# Blue Print Bulletin

## Toyota Carina E and Avensis Water Pumps

ADT39145 (Aisin) & ADT39177 (SEM) - 7AFE 1.8 engine

ADT39143 (Aisin) & ADT39159 (SEM) - 4AFE 1.6 engine

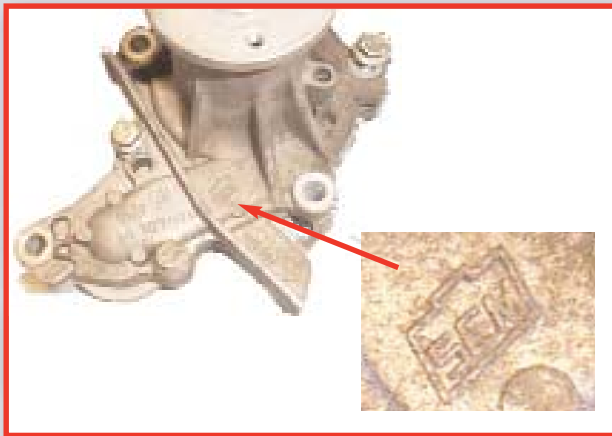
**The ADT39143 and ADT39145 pumps will contain the front casing only, and must only be fitted to the Aisin type rear casing.** If fitted to an SEM type rear casing, the retaining bolts will not fit correctly and water will leak from the gasket.

**If you are unable to identify the manufacturer of the water pump to be replaced, ADT39159 and ADT39177 are supplied complete with front and rear casings pre-assembled. These part numbers will replace all manufacturers.**

**The original SEM type pump** can be identified by the manufacturer's mark on the outer casing (see picture)

Side profile of the replacement SEM type pump with the front and rear casings pre-assembled.
